Department of Transportation
and Public Facilities
Southeast Region

JNU AMHS - AUKE BAY
FAST VEHICLE FERRY
SUPPORT FACILITY
SHAK-9500(103) ~ 67763

As-built Plans

1 GROUND FLOOR PLAN

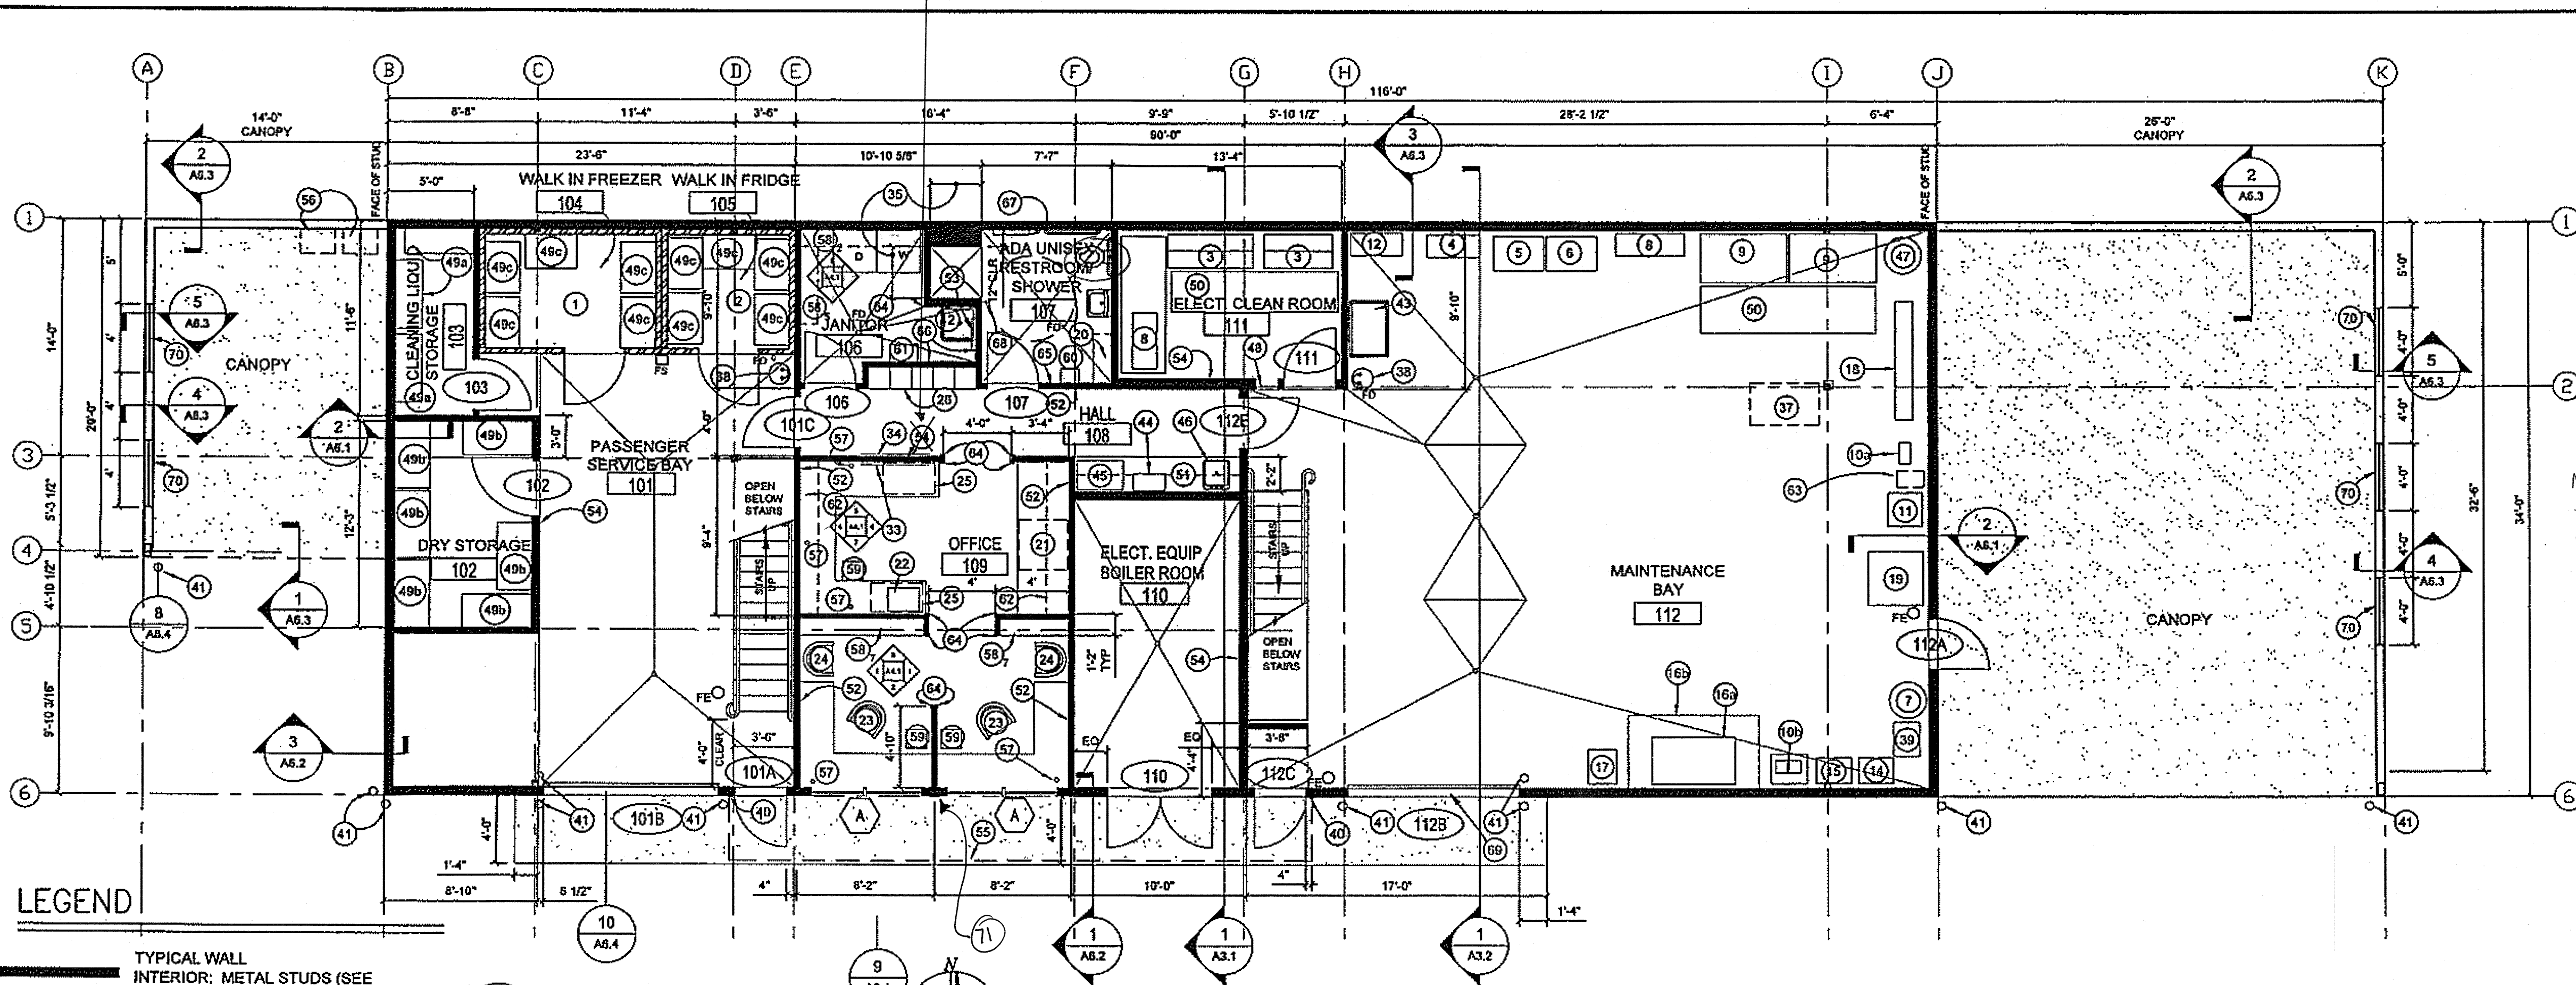
4" stud wall per DCVR #14 6/13/08 Response

Noted: Fil original spec
for wall mount water closet,
changed to floor mount water closet
per Design Alaska 6/18/08
response to DCVR #7

1 SECOND FLOOR PLAN
A1.2 3/16"=1'-0"

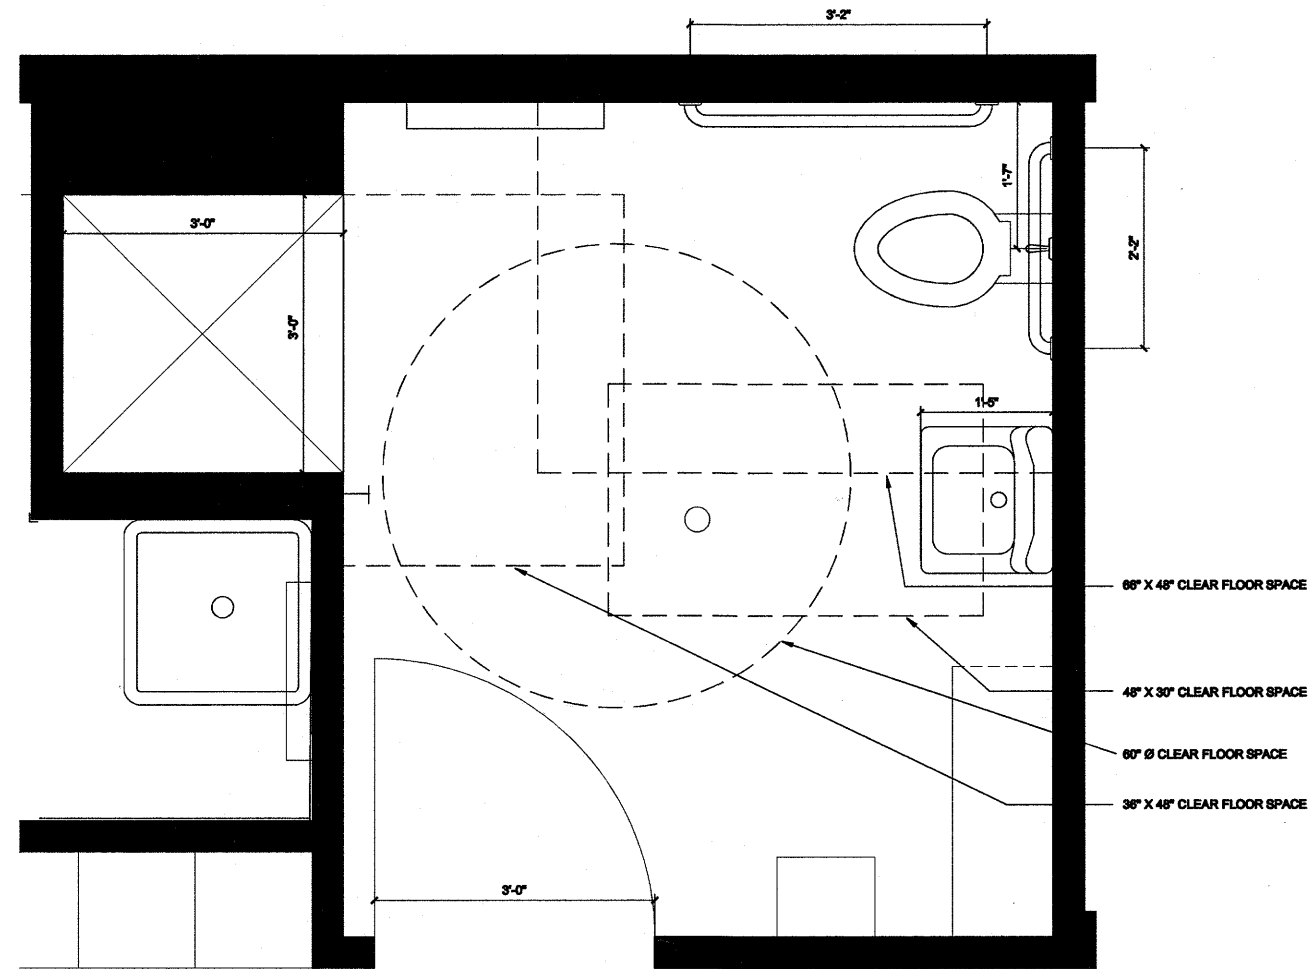
SHEET A1.2, DOOR TYPES. Add Type A similar to door type B except width of glazing measured from strike side is 5".

SHEET A1.2, ROOM FINISH SCHEDULE. Replace Room Finish schedule with the attached Room Finish Schedule, included as Attachment 2 to this addendum.

SHEET A1.2, ROOM FINISH SCHEDULE. Add note 6 to read: "Furr down ceiling in room 107 with 2 x 4 at 16" oc"

SHEET A1.2, ROOM FINISH SCHEDULE. Note 4. Change Note 4 to a General Note covering all rooms except rooms 110, 202 and 203.

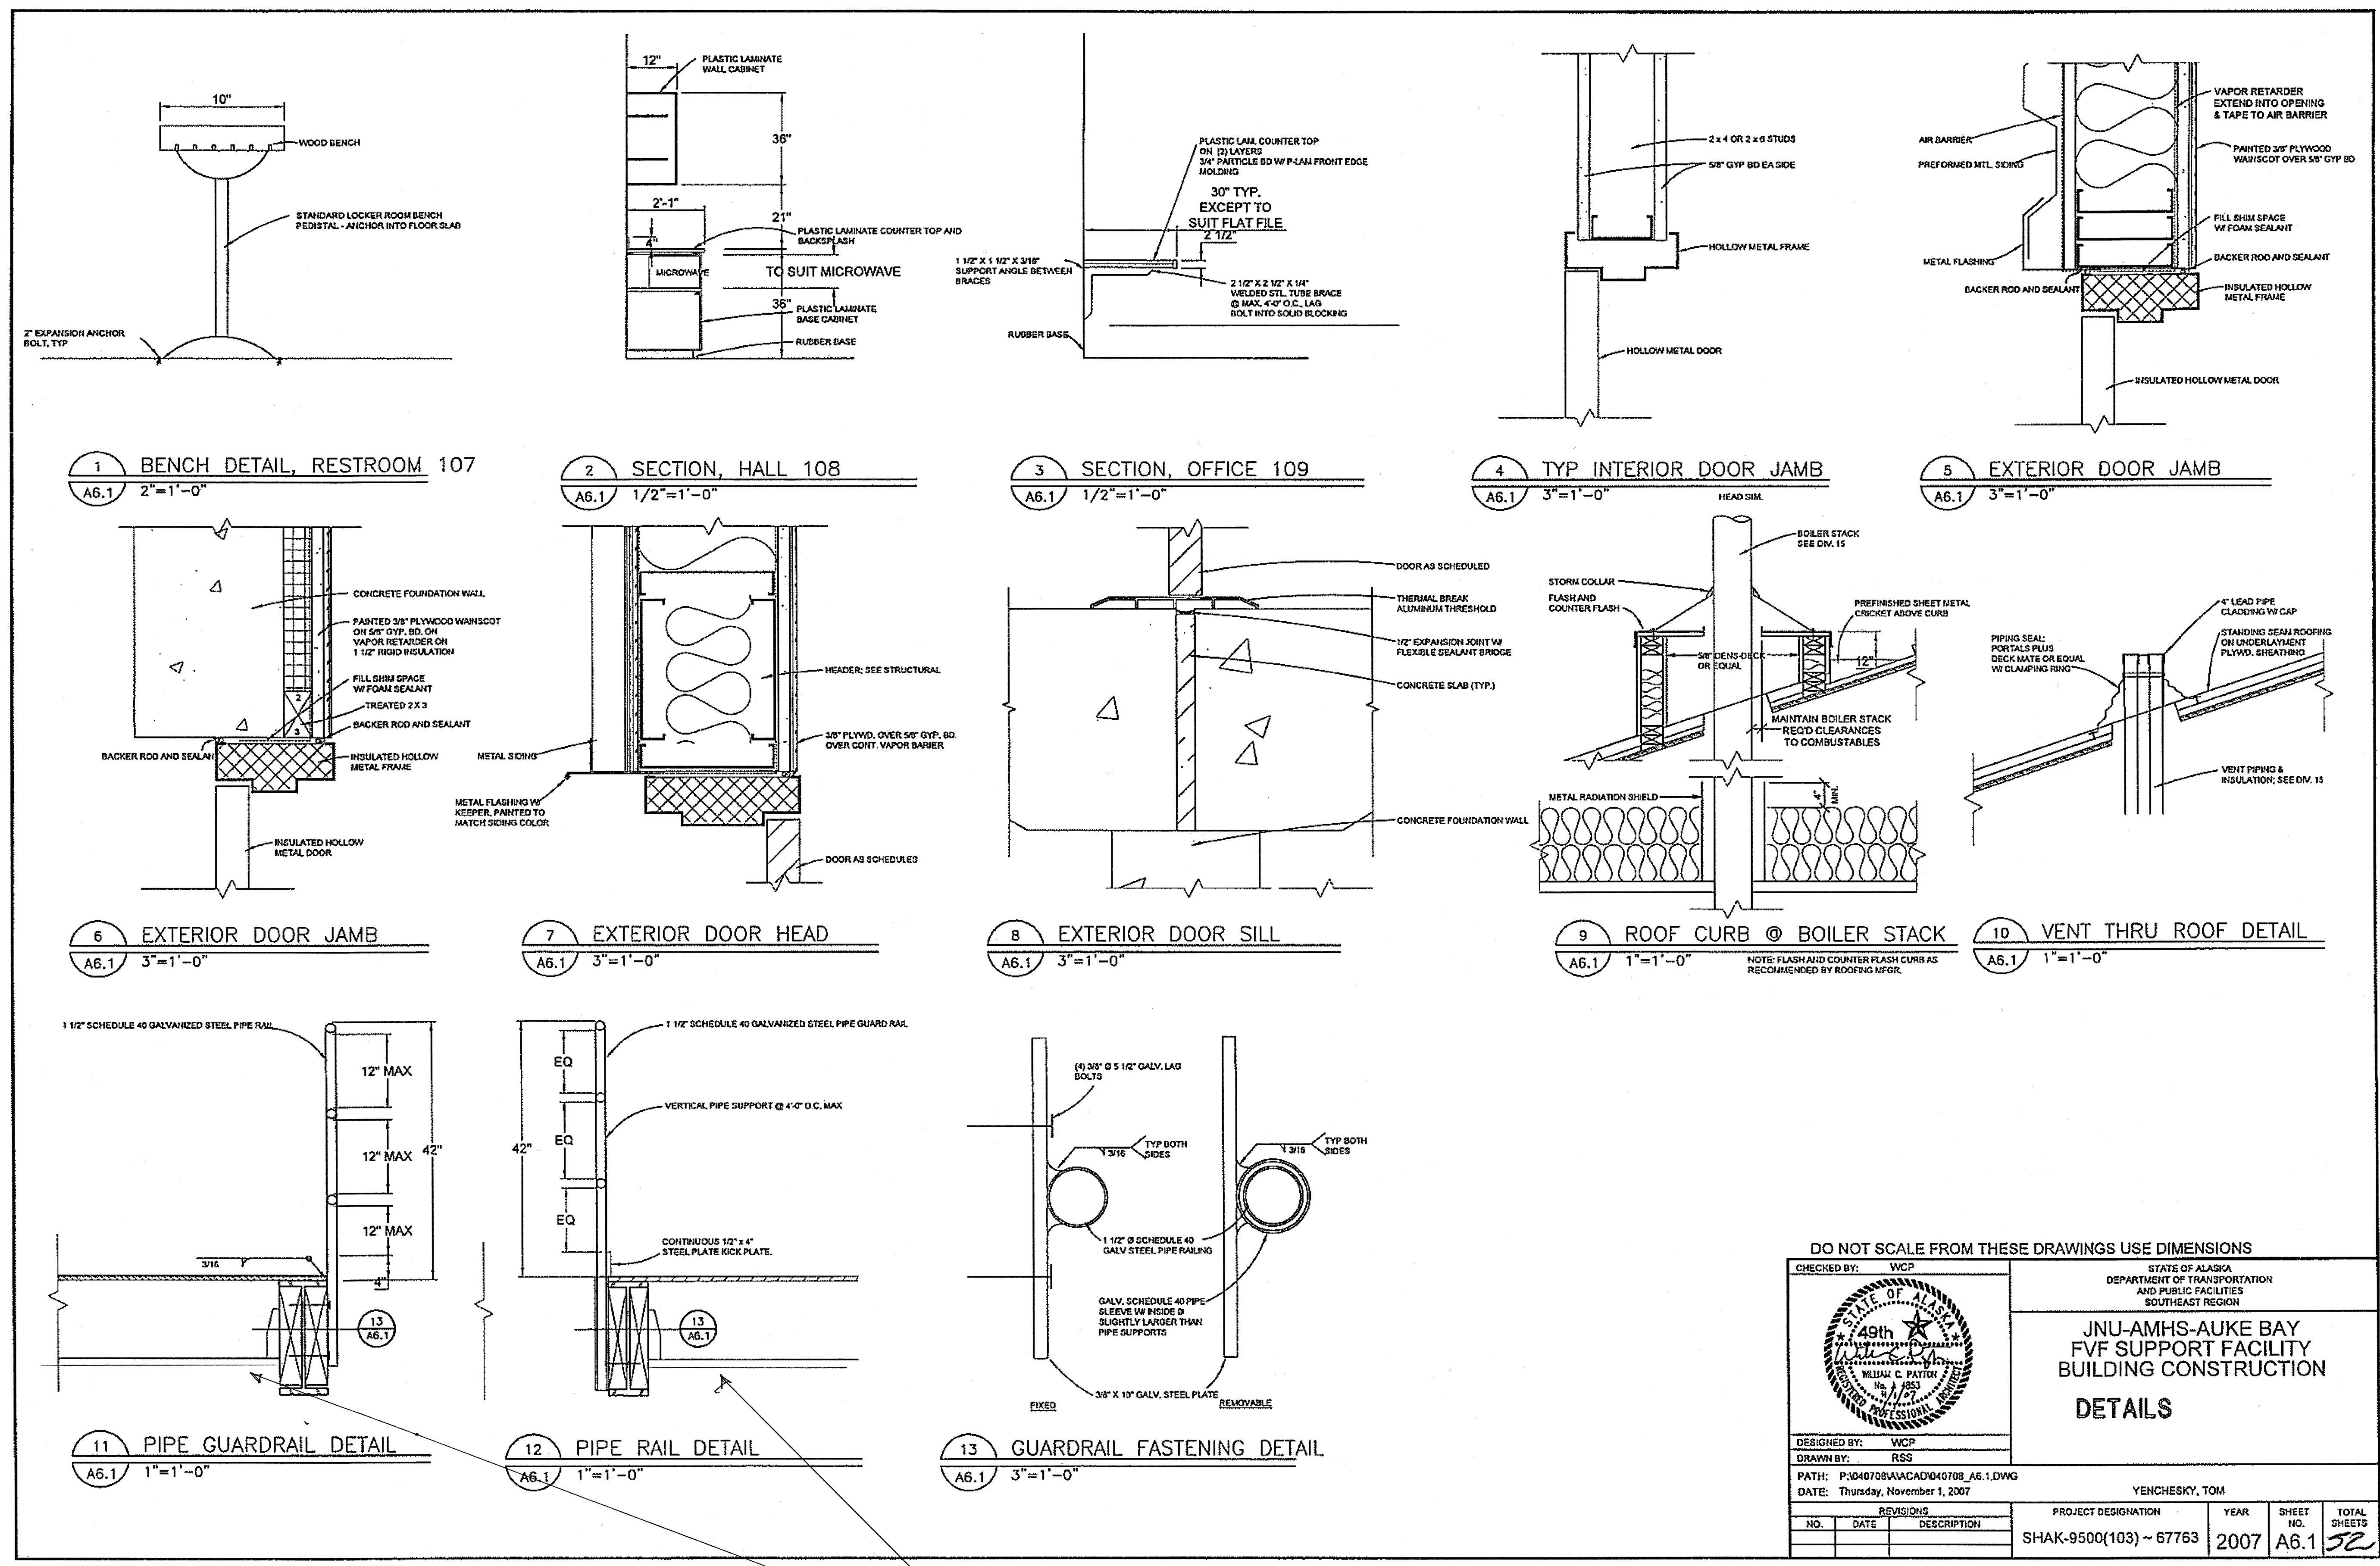
5" Gypsum per Addendum # 3

WALL SECTIONS

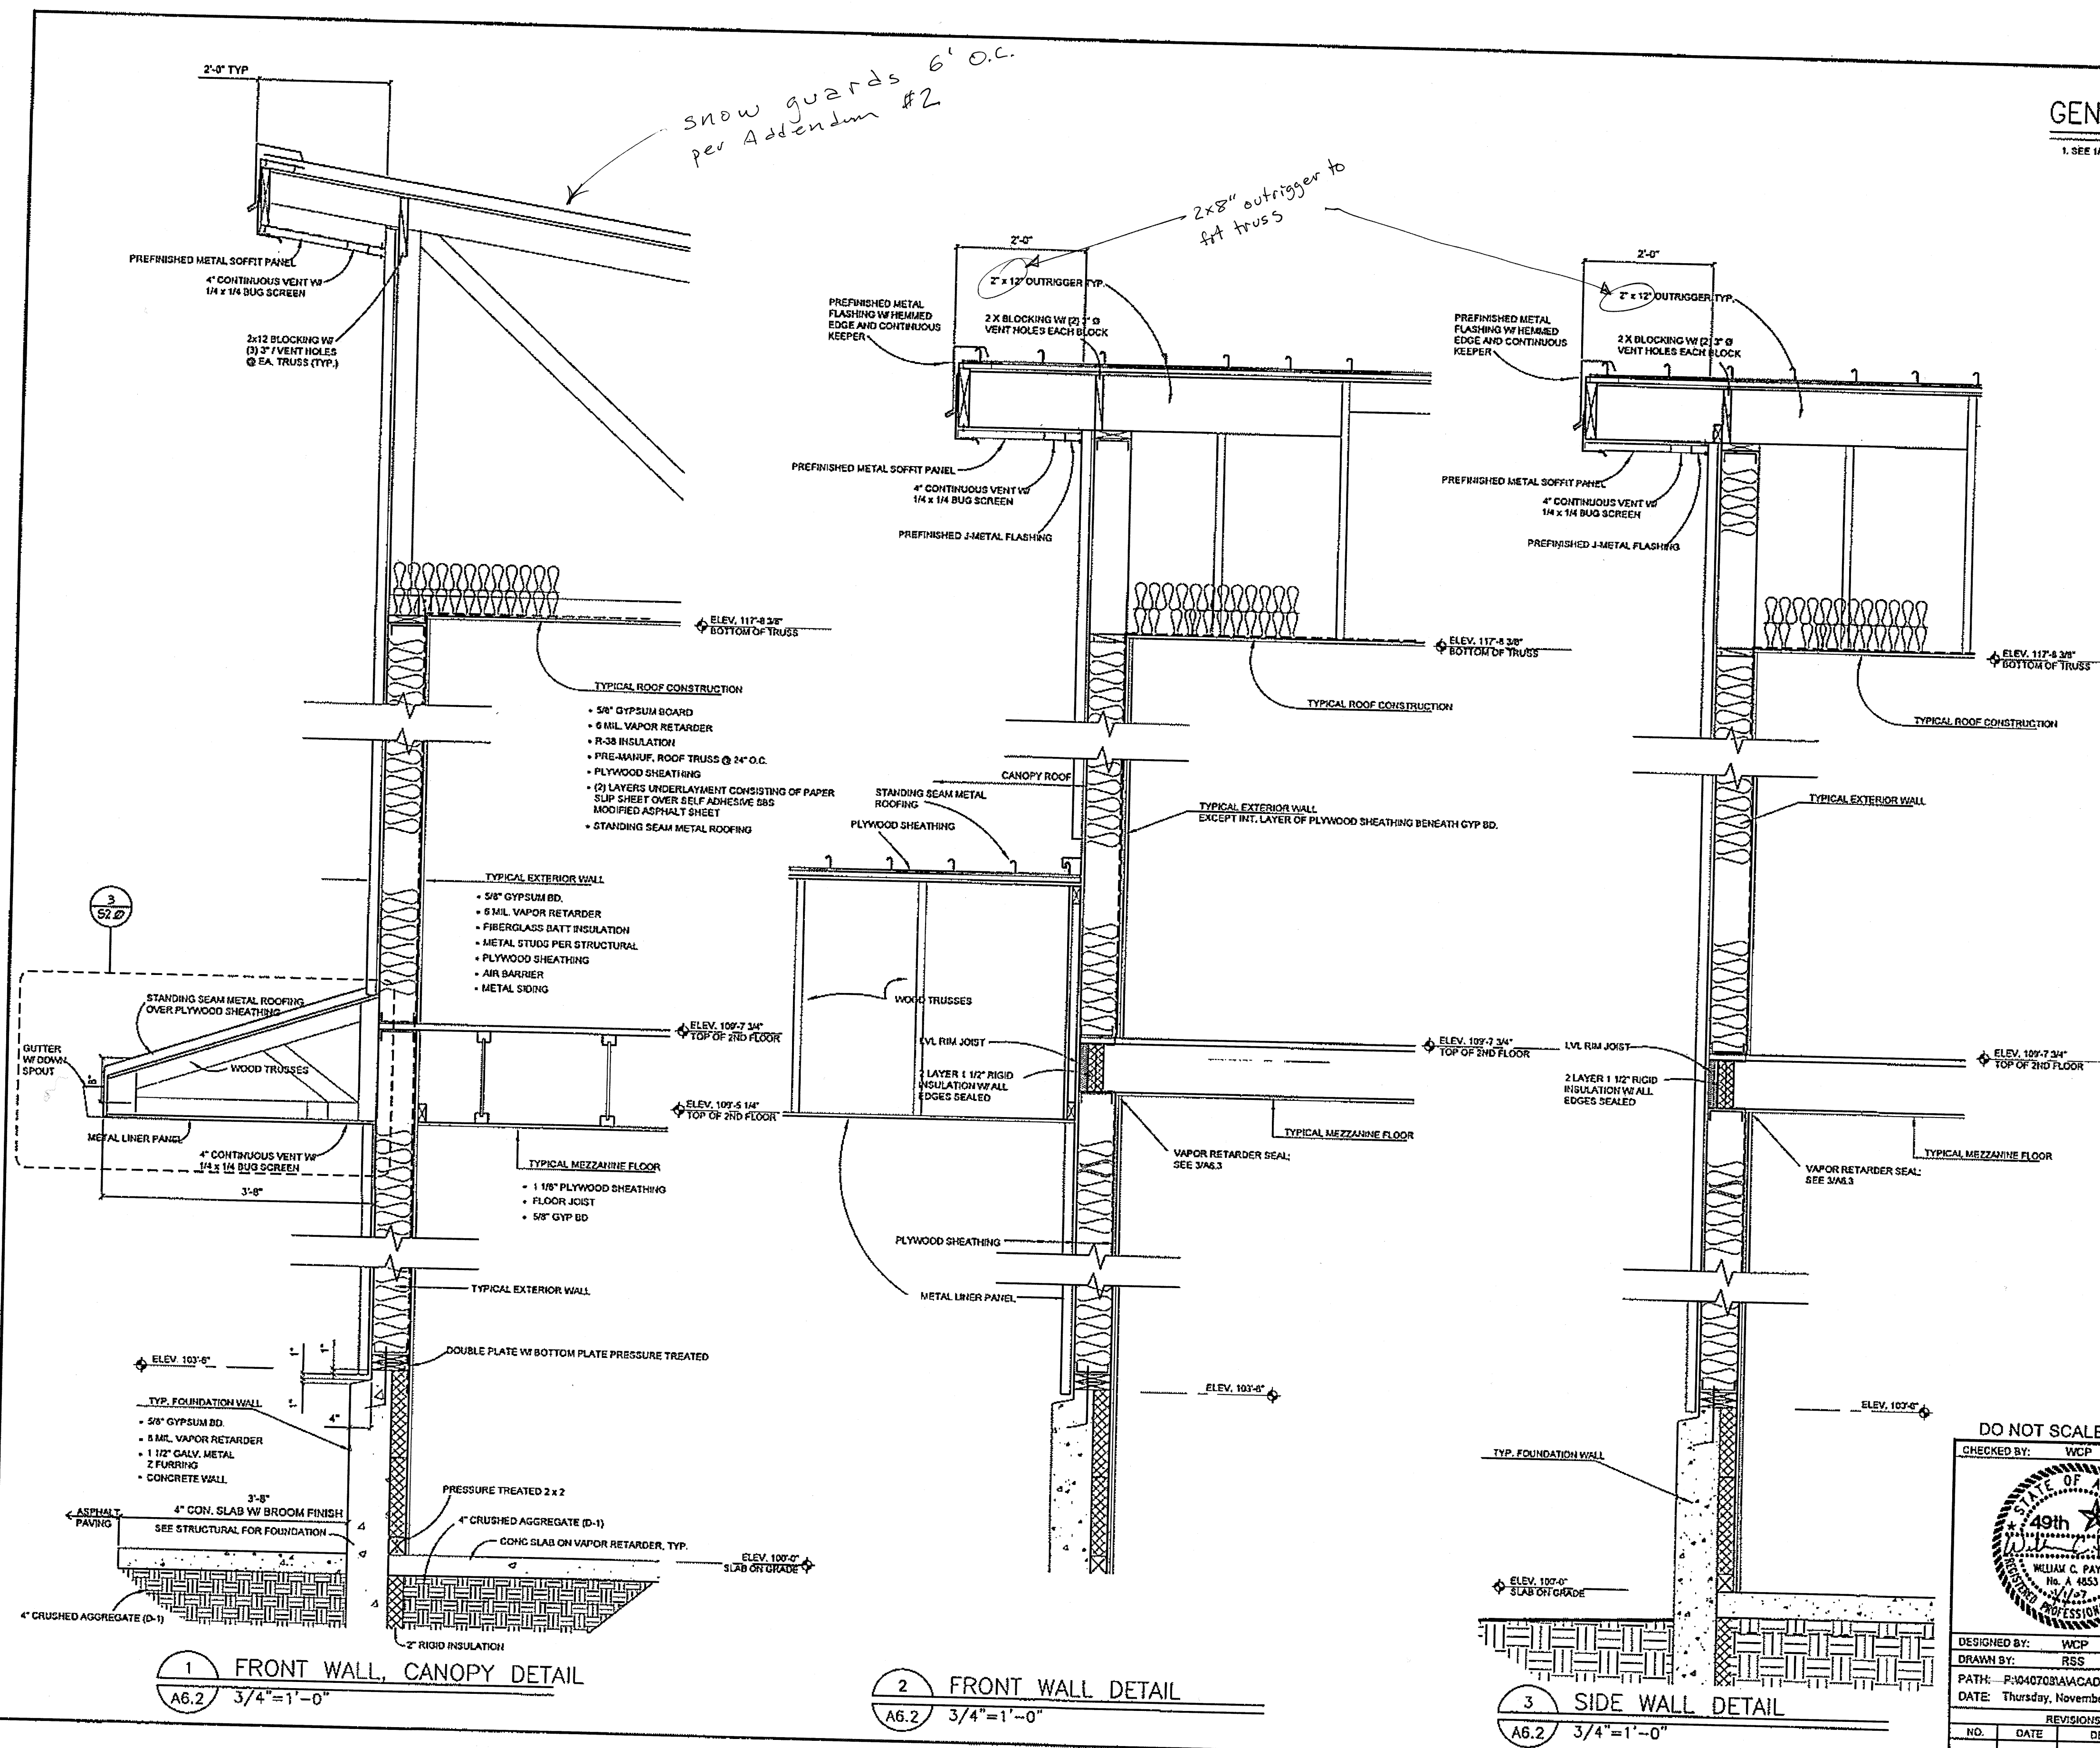
snow guards 6' O.C.
 per Addendum #2
